November 17, 2006

Subject: **Docket Nos. 50-206, 50-361, 50-362 and 72-41
Request for Emergency Plan Change
Proposed Revision to the
Protective Action Recommendation Methodology
San Onofre Nuclear Generating Station, Units 1, 2 and 3
and Independent Spent Fuel Storage Installation**

**San Onofre Nuclear Generation Station (SONGS)
Emergency Plan Proposed Change to the
Protective Action Recommendation (PAR) Methodology**

Proposed EPZ PAR Methodology

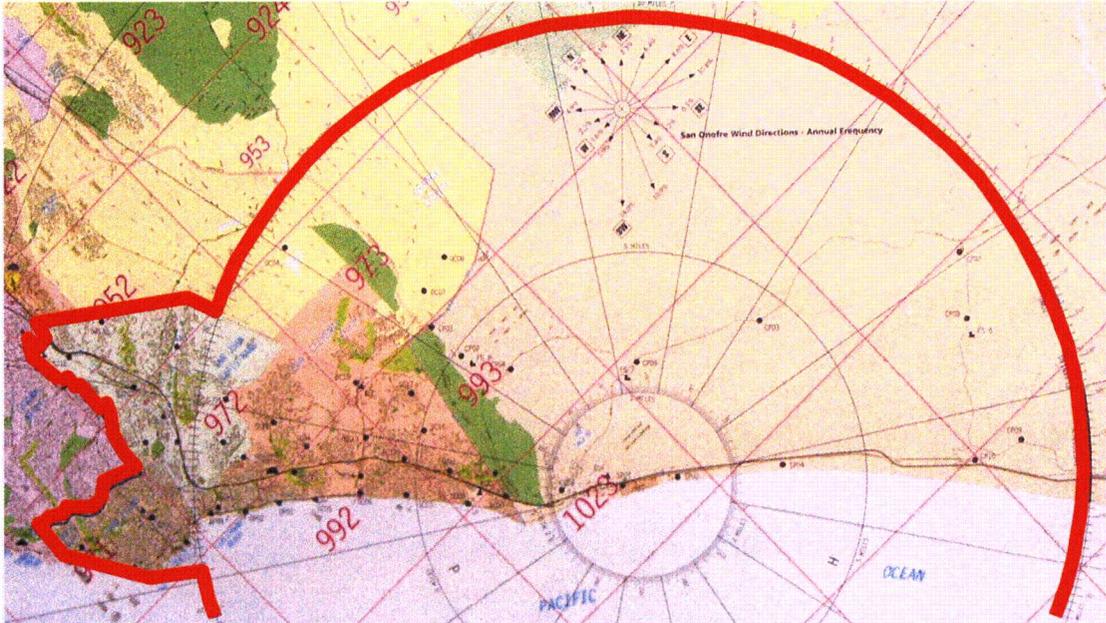
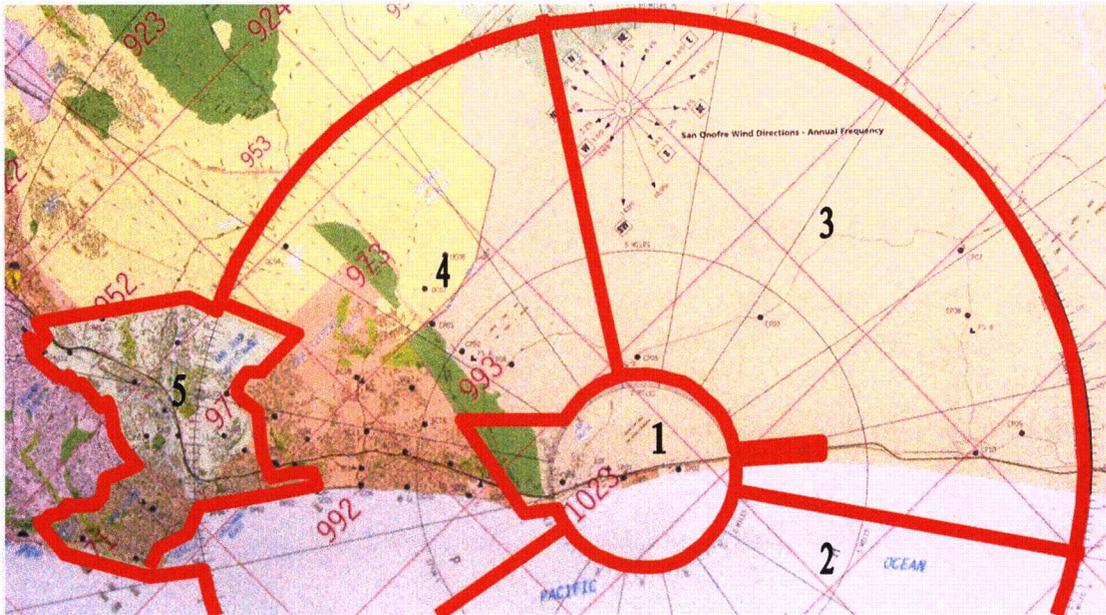
The current SONGS PAR methodology for a General Emergency (GE) evacuates or shelters the entire Emergency Planning Zone (EPZ) regardless of wind direction or radiological consequences. It is essentially an “all or nothing” PAR for the EPZ.

The proposed PAR methodology is more risk informed. It divides the EPZ into Protective Action Zones (PAZ) so that wind or plume direction and radiological consequences are considered. This allows the closest-in population to be evacuated first, dose consequences to be considered, and considers geopolitical boundaries. The new methodology also better aligns the concept of a “puff” release with the regulations.

In the current PAR methodology the entire population within the EPZ (shown above by the bold line) is evacuated or sheltered regardless of the wind direction or dose at a General Emergency.

The new PAR methodology considers wind direction so that only the affected PAZ 2, 3, or 4 will be evacuated or sheltered. A PAR for PAZ 5 will occur only if the wind direction is towards PAZ 5 and actual or projected dose at the PAZ 4/5 border reaches a predetermined level (See discussion on page 7).

TABLE 6-3 - PROTECTIVE ACTION RECOMMENDATION (PAR)

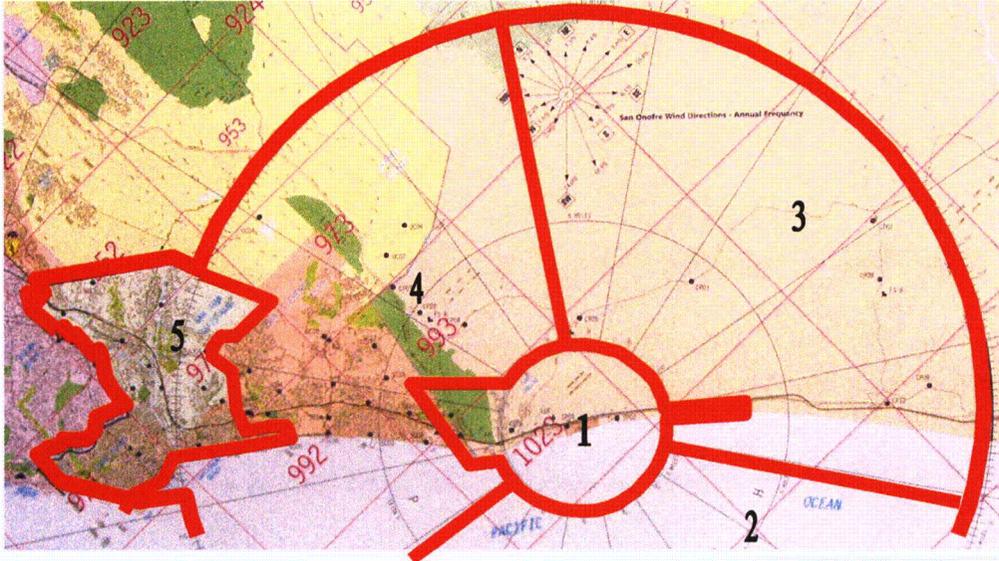
Condition	Protective Action Recommendation
Unusual Event	None Required
Alert – with a security event	Evacuate the State Beach
Alert – with an event related radiological release	
Site Area Emergency	Evacuate the State Beach
General Emergency – with NO known evacuation impediments	Evacuate the State Beach. Evacuate PAZ 1 and the adjacent downwind zone(s), and ingest KI for the public in the affected PAZs. (This applies to PAZs 1, 2, 3, or 4 only)
General Emergency – with KNOWN evacuation impediments	Evacuate the State Beach. Shelter PAZ 1 and adjacent downwind PAZ(s). If wind is towards PAZ 2, then evacuate that zone. Ingest KI for the public in the affected PAZs (Applies to PAZs 1, 2, 3, or 4 only)
General Emergency – with an event related radiological release <1 hour in duration	
General Emergency – with a dose ≥ 5000 mrem TEDE at the EAB (measured or projected) and the wind towards PAZ 5, and NO known evacuation impediments	Evacuate the State Beach. Evacuate PAZ 1, 4, 5, and ingest KI for the public in those PAZs

General Emergency – with a dose ≥ 5000 mrem TEDE at the EAB (measured or projected) and the wind towards PAZ 5, and KNOWN evacuation impediments	Evacuate the State Beach. Shelter PAZs 1, 4, 5, and ingest KI for the public in those PAZs

Emergency Planning Zone Depicting the Five Protective Action Zones

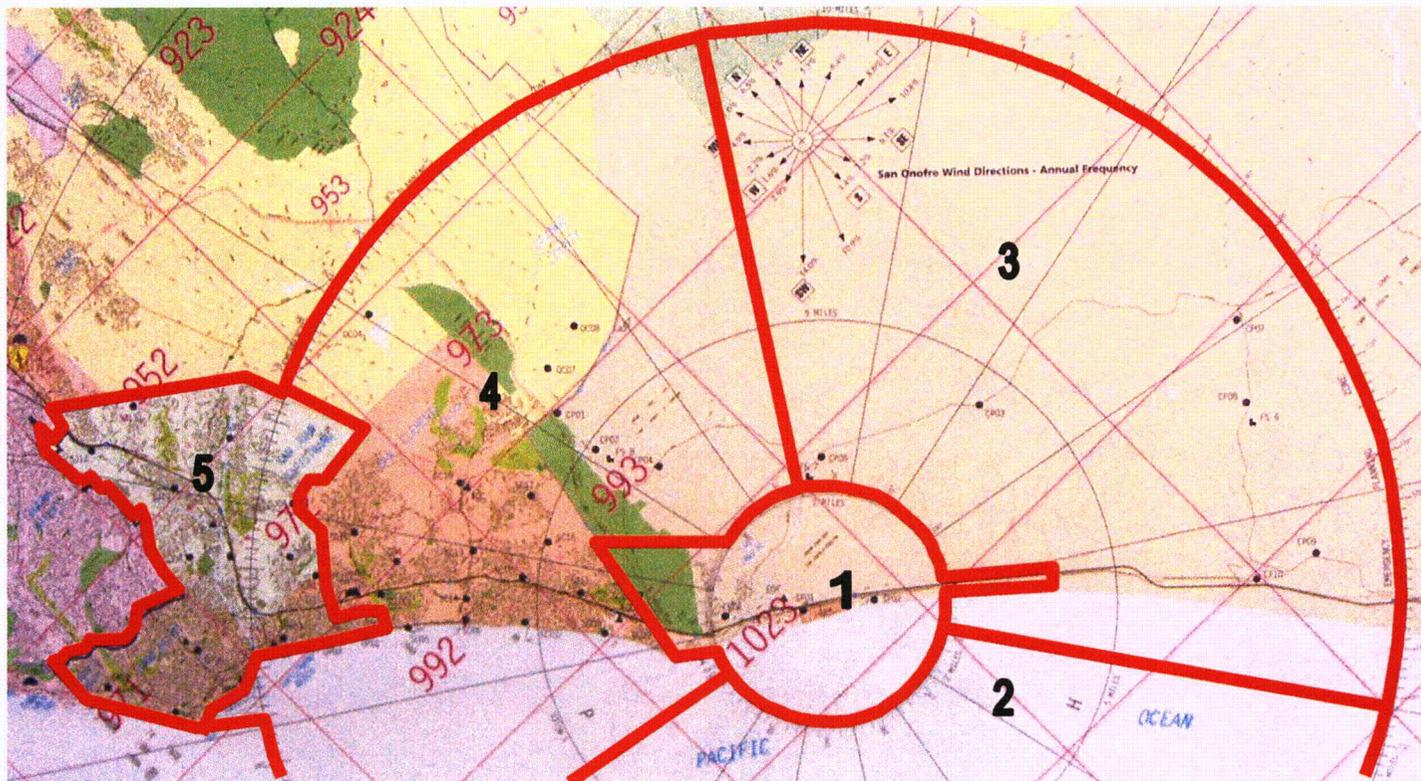
The IPC recommended the formation of five Protective Action Zones within the existing Emergency Planning Zone (EPZ) where protective action would be taken for PAZ 1 (roughly 2 miles around the plant) and the affected downwind PAZ(s) (PAZ 2, 3, 4, 5) as appropriate. The decision maker’s voted unanimously to approve and support this change to the current (diagram of the PAZs is attached). Discussion points follow.

Establish five Protective Action Zones. The range of protective actions would include shelter or evacuate PAZ 1 and the affected downwind PAZ(s) and ingestion of KI during General Emergency declarations.
